## **US-APWR**

# **Modifications to Standard Plant: Introduction**

**September 22, 2011**

**Mitsubishi Heavy Industries, Ltd.**

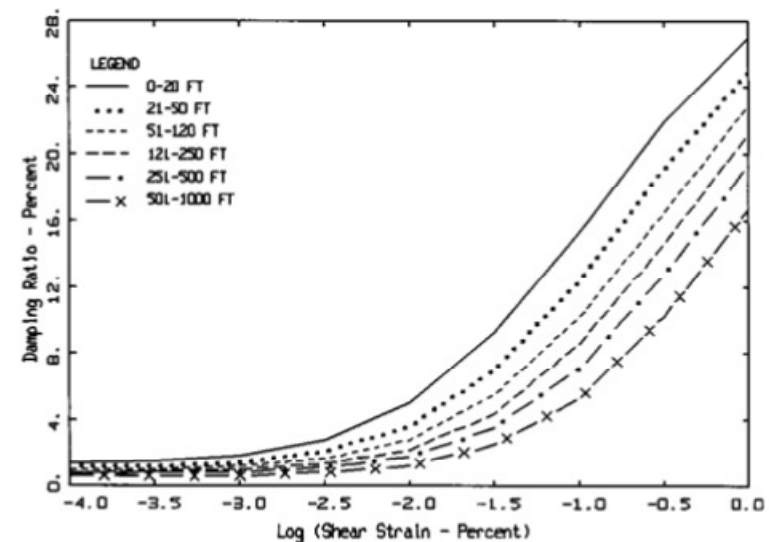
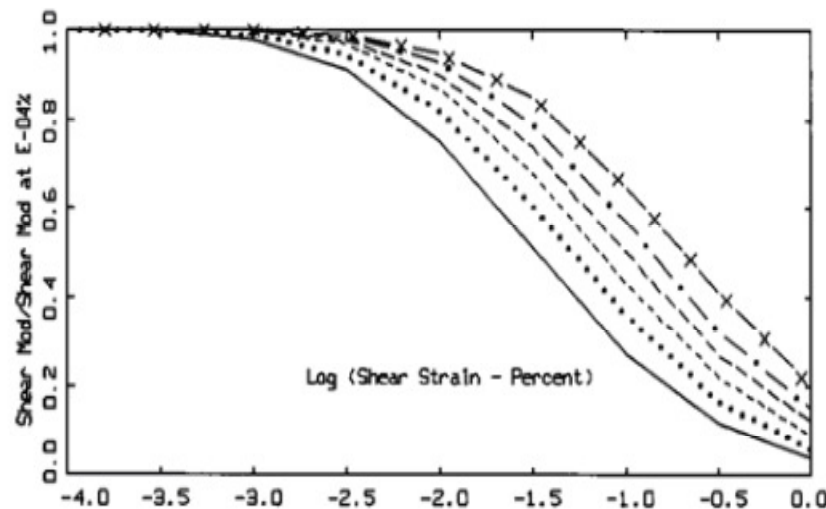
- Modifications of standard design basis database of generic site profiles for site-independent SSI analyses are:
  - Soil Profiles 560-100 and 560-200 are removed from the standard seismic design database
  - EPRI soil degradation curves are used instead of unpublished rock degradation curves
  - Hard rock base is replaced with sedimentary rock type of profile with gradual increase of stiffness
  - Profiles with nominal S-wave velocity of 900 m/sec are modified by introducing steeper increase of rock stiffness with depth.

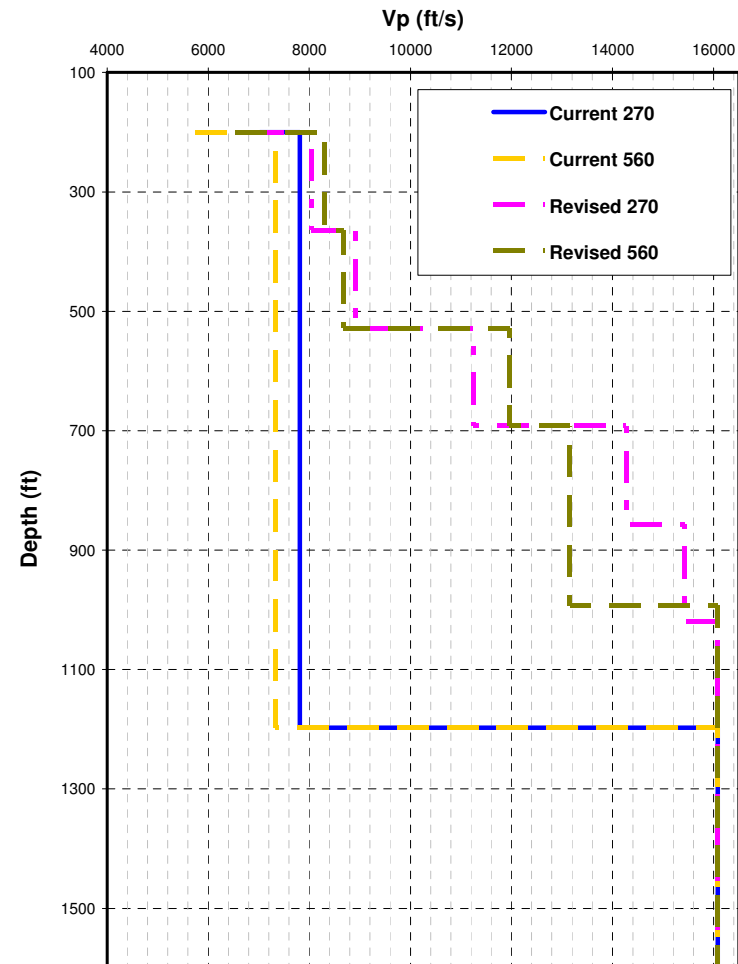
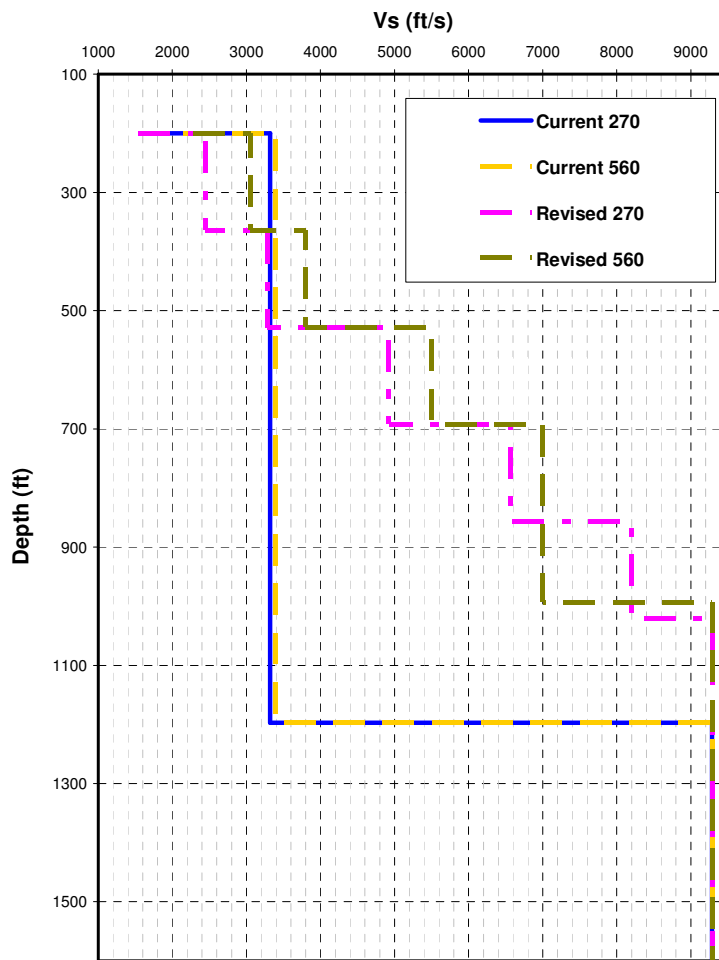
- Rock base is replaced by sedimentary or weather rock section overlying Precambrian basement material that is appropriate for both in Eastern and Western US

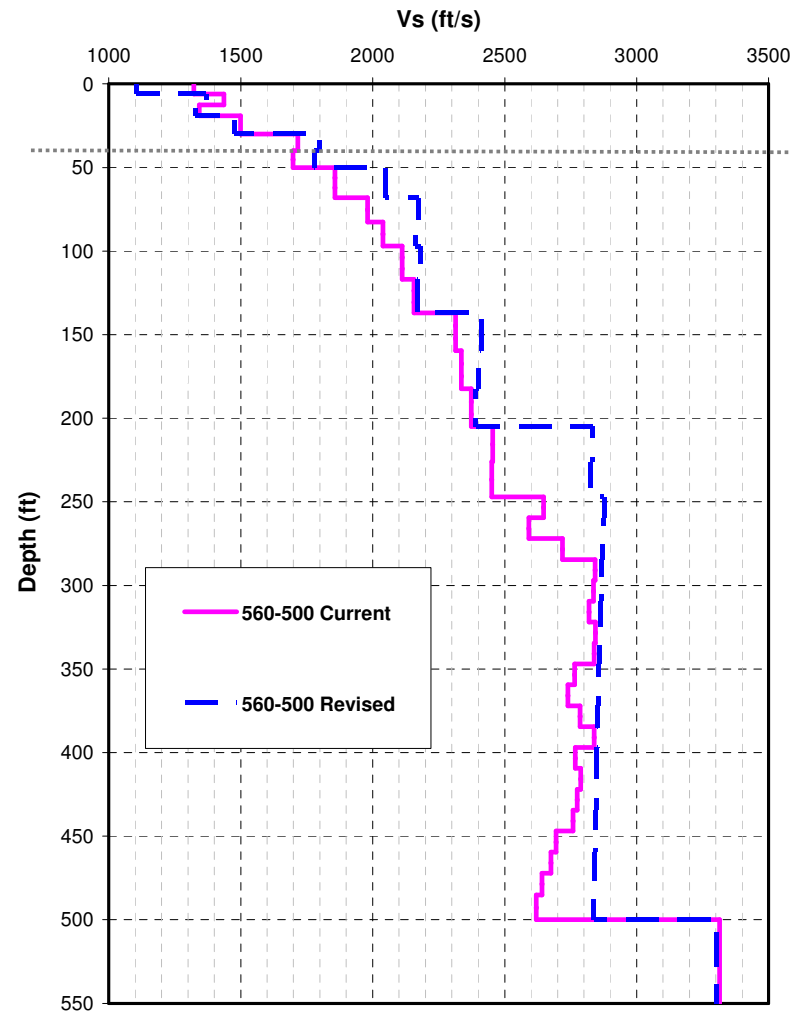
- Revised degradation curves and rock base yield strain compatible properties of generic profile 560-500 do not exhibit significant decrease in stiffness with depth

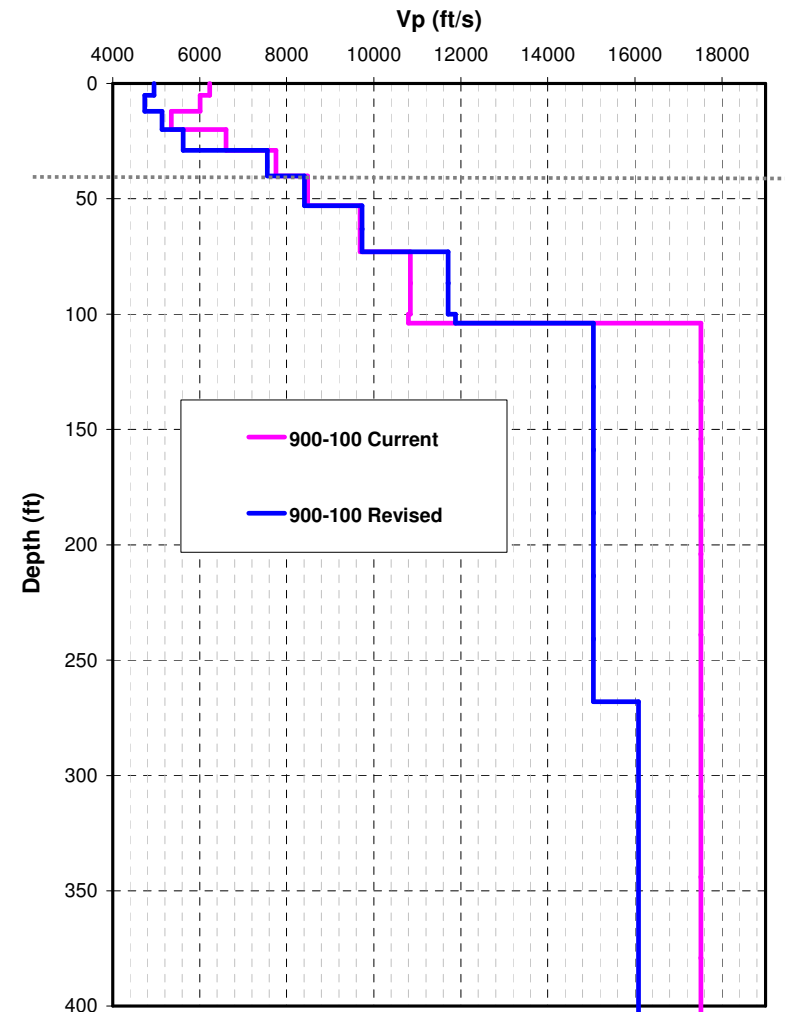
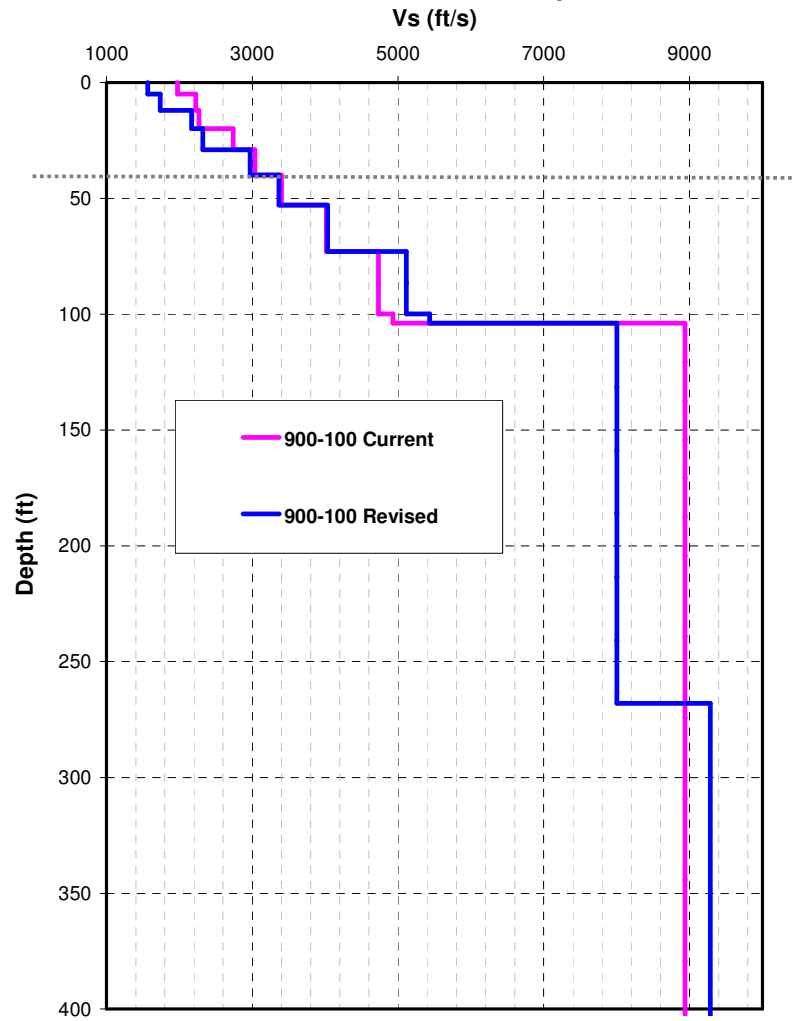
- Generic Profile 900-100 is modified by introducing steeper increase of top strata stiffness with depth

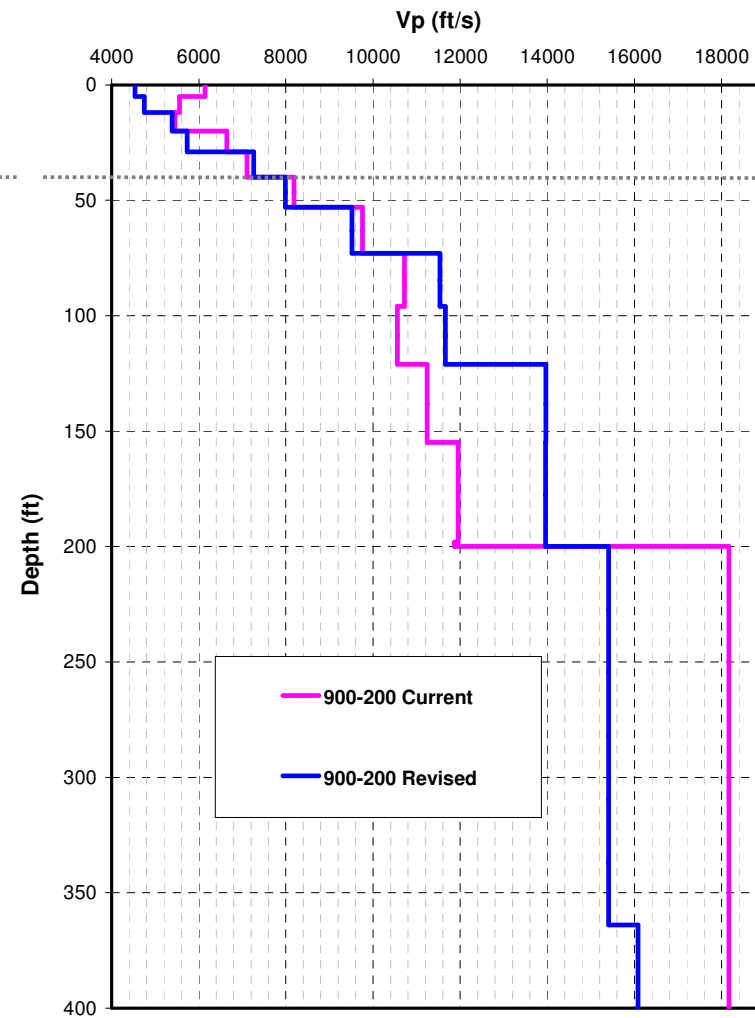
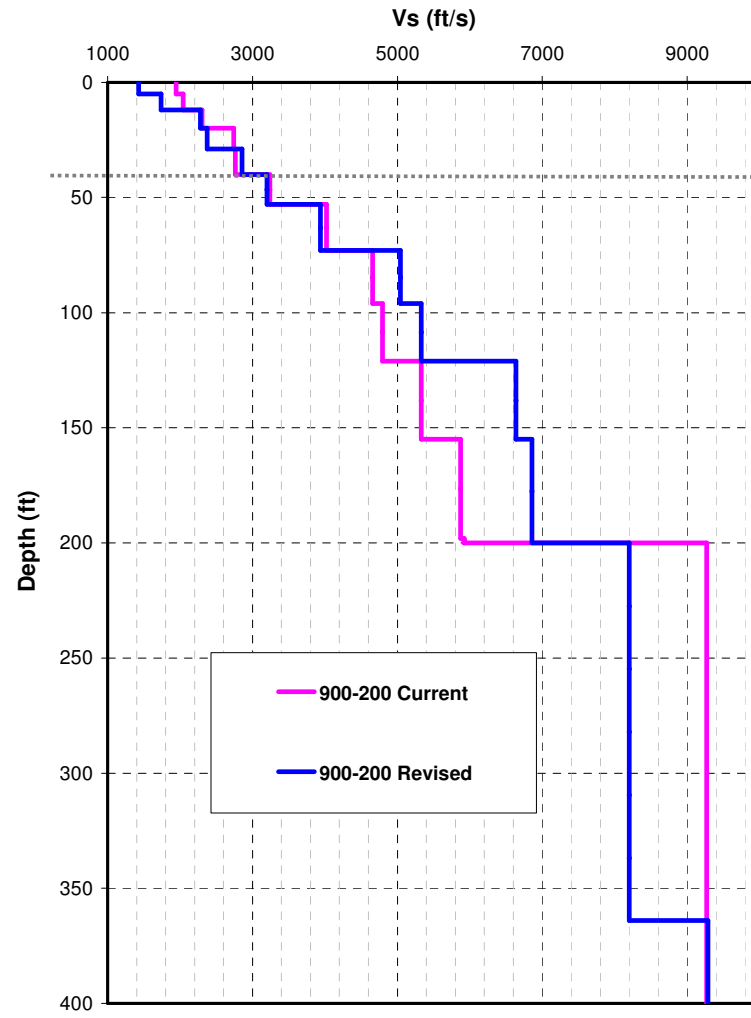
- Generic Profile 900-200 is modified by introducing steeper increase of top strata stiffness with depth

DCD and Modified Nahanni Horizontal Spectra - Component X

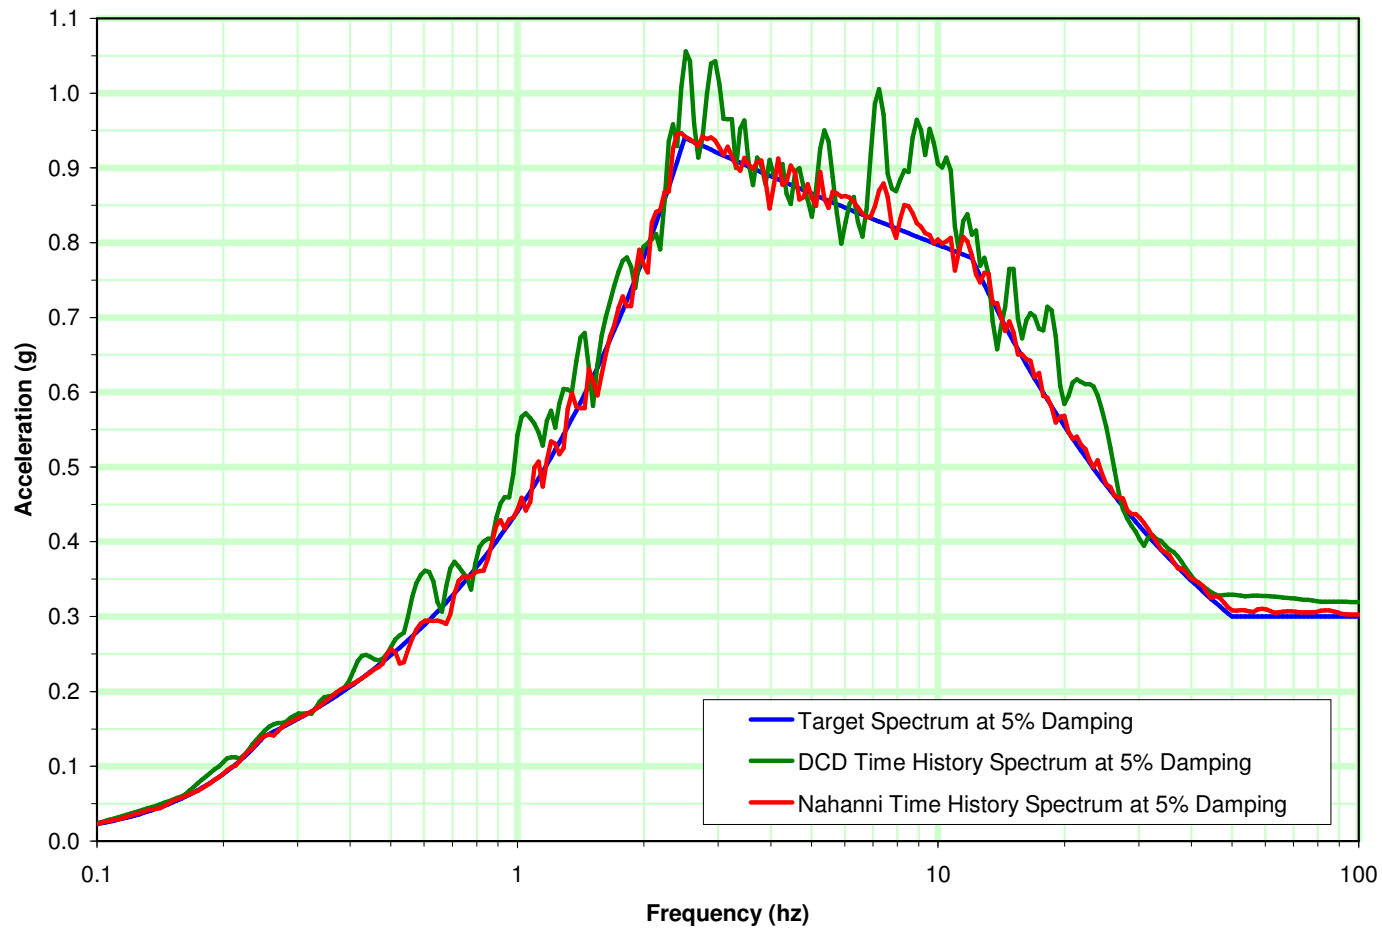
- The revised time histories resolve challenges associated with contact area ratio and subsequent bearing pressures
- The revised time histories help resolve sliding stability challenges
